## Planning Commission Study Session

**SUBJECT:** DR19-175, MESA CUSTOM MACHINING CORP

To allow for the expansion of an existing industrial building.

landscape plan  
scale: 1\"/>

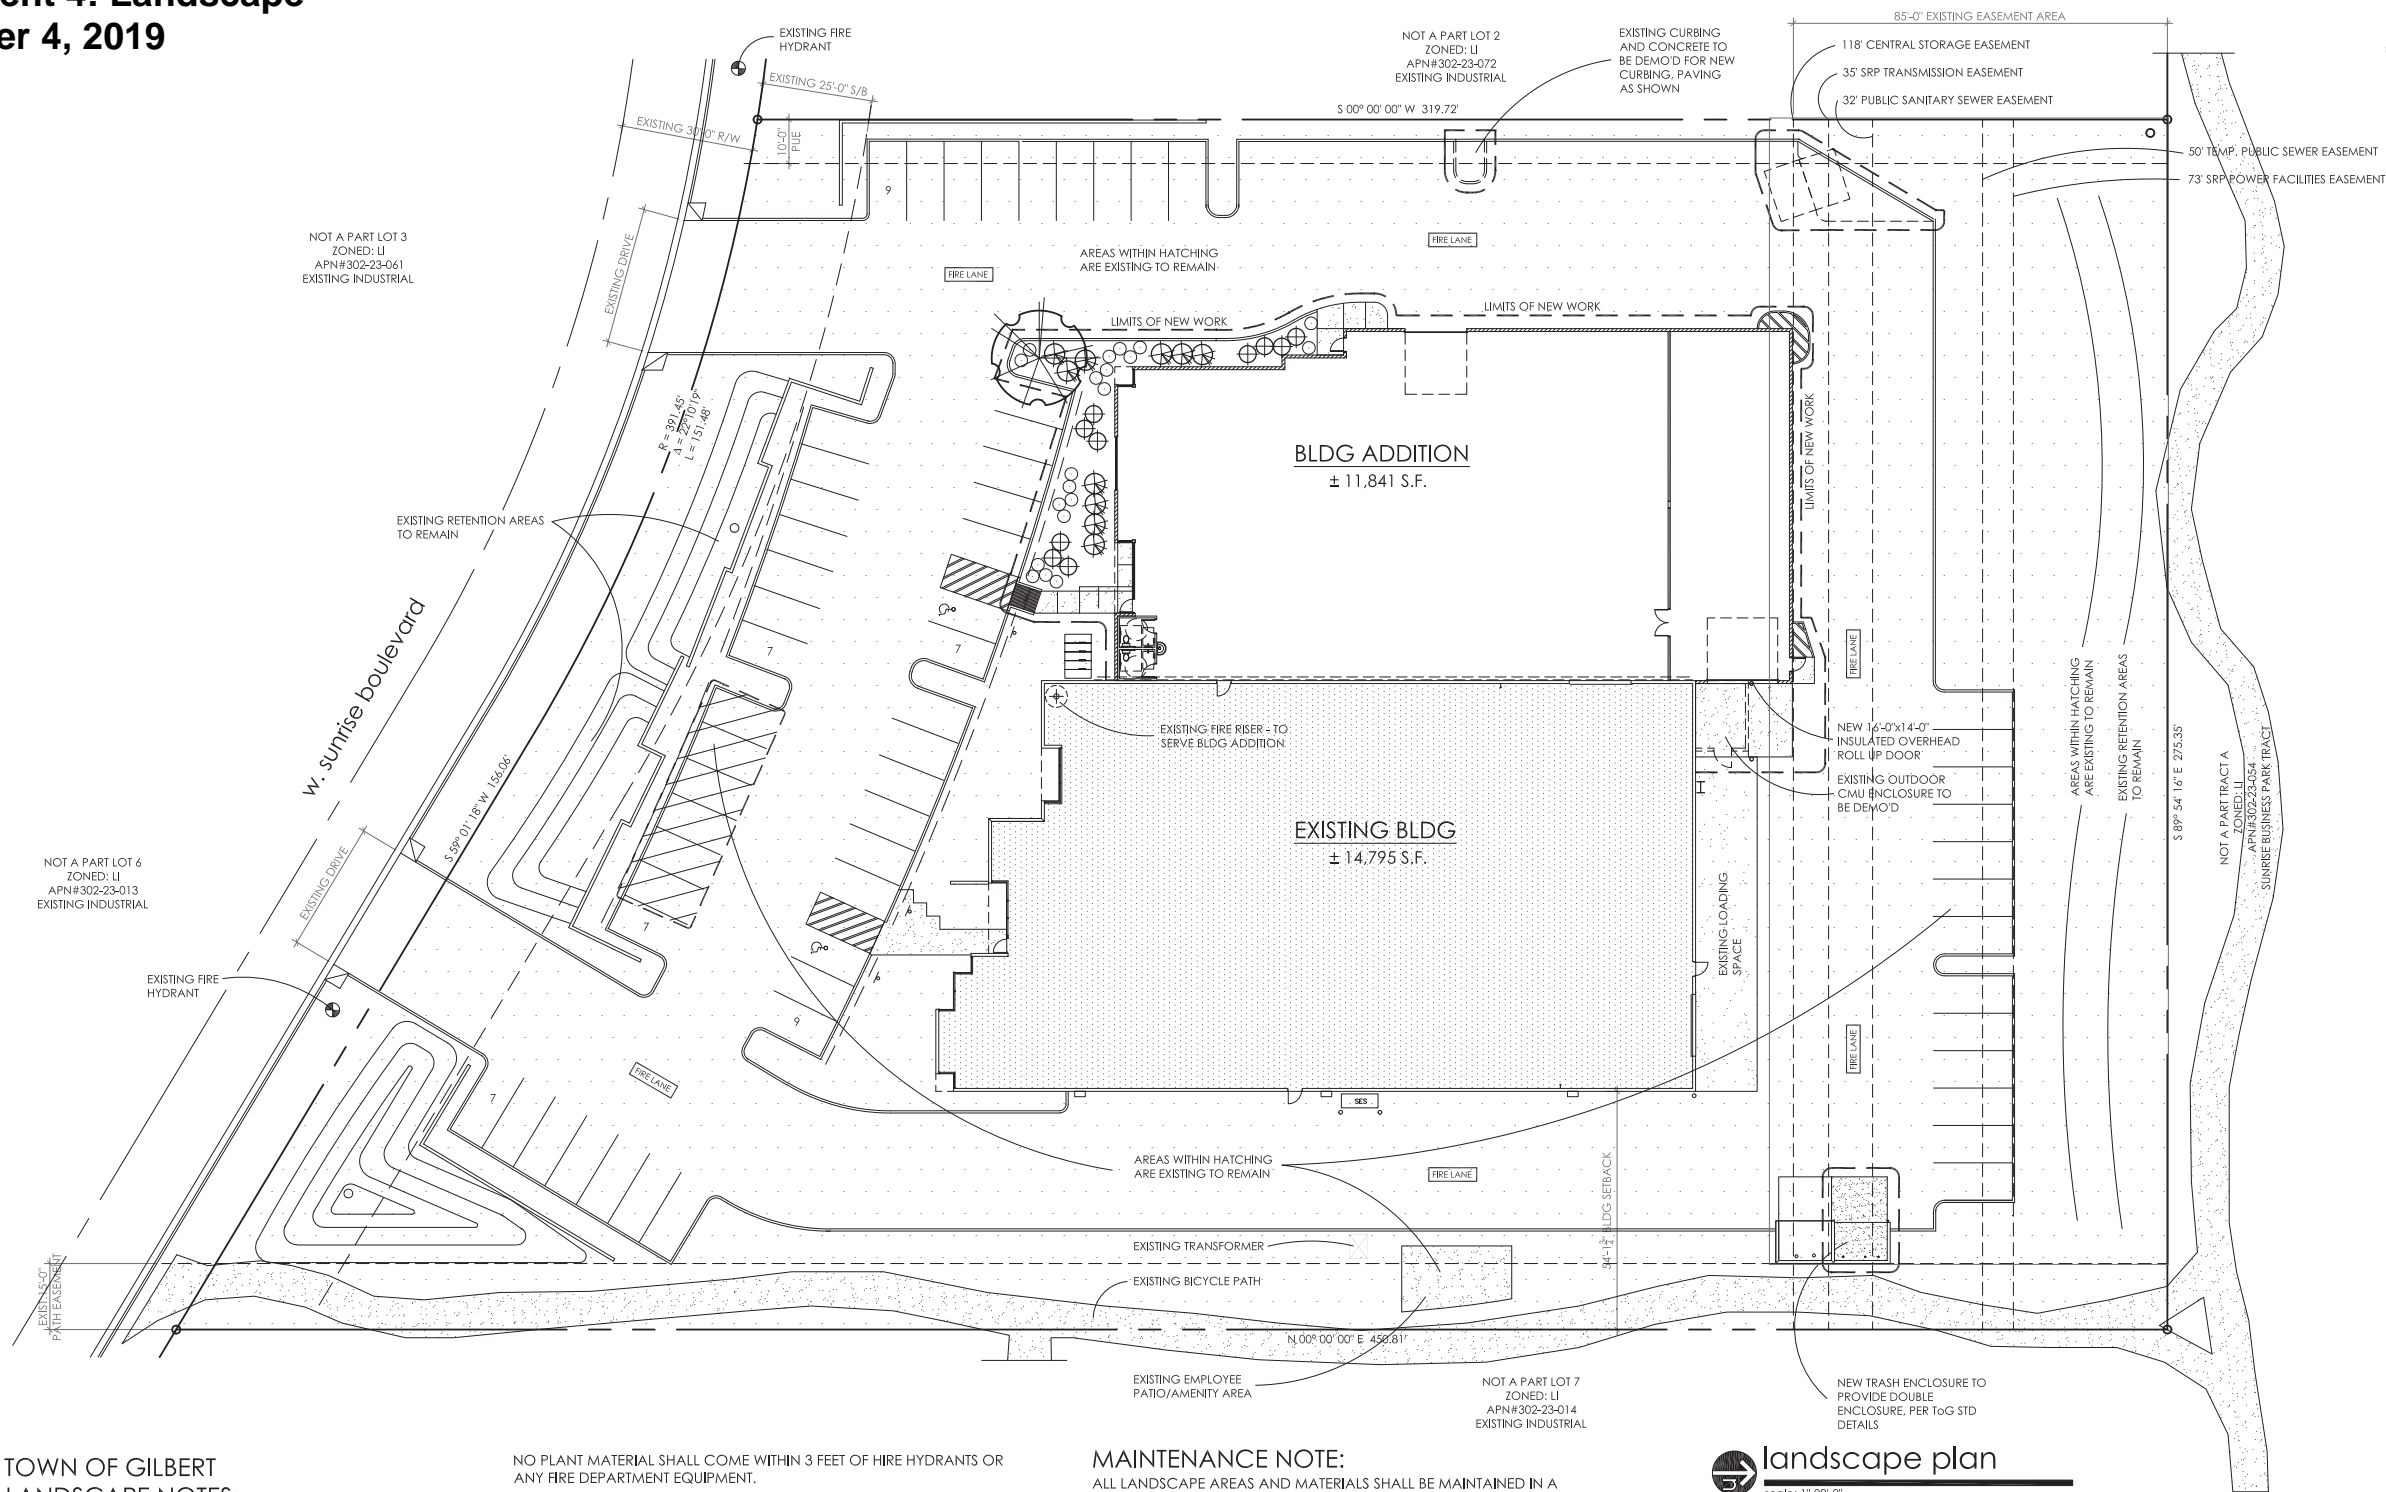
A majority of the landscaping for the subject site is existing from the first phase of the development. The only new landscaping proposed is foundation landscaping located on the south and west sides of the building expansion. The landscape palette proposed included Chinese Elm, Green Cloud, Red Yucca, and 'Gold Mound' Lantana. All landscaping proposed either matches or complements the existing landscaping.

electrical site lighting plan

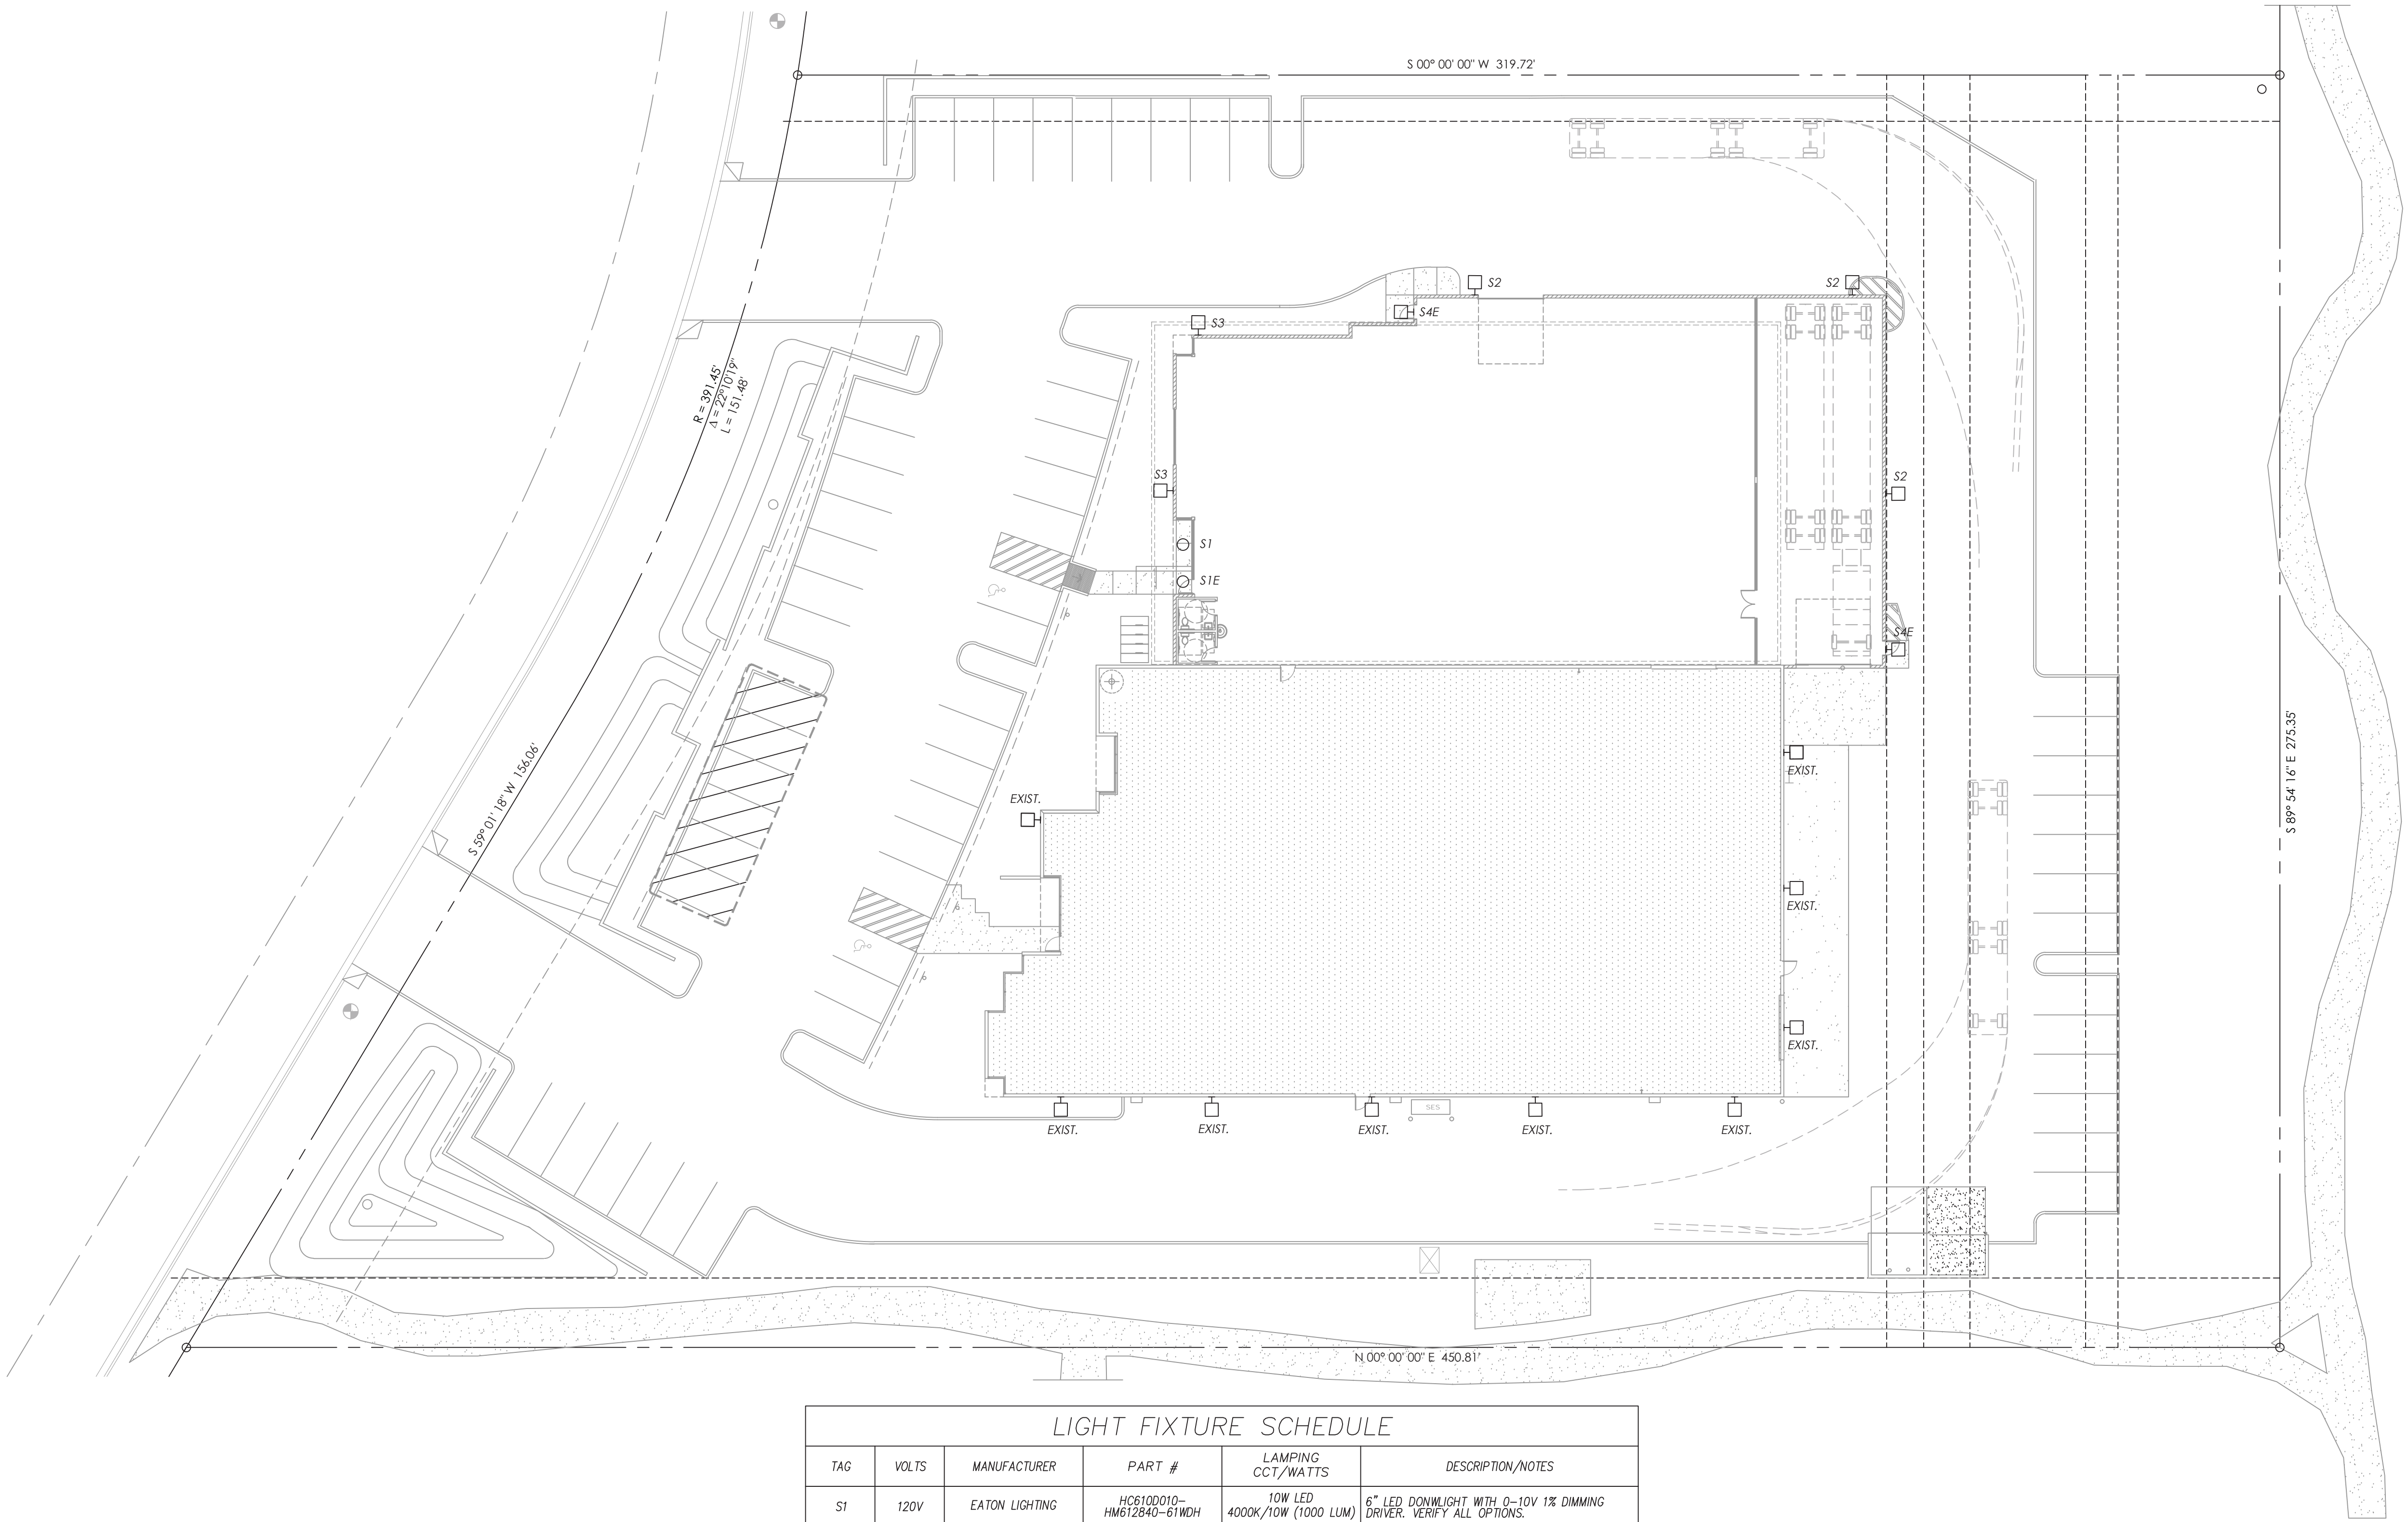
There are only two (2) lighting types proposed, building mounted and downlights. The building mounted are located around the exterior of the building with the downlights located at the building entrance. The building mounted lights are located at 16' on the building. Per LDC 4.103. A.4., wall-mounted fixtures shall be a maximum height of 14 feet above grade, measured to the bottom of the light source. The applicant is aware of the requirement, as it was addressed in the first review comments. All site lighting will be required to comply with Town codes.
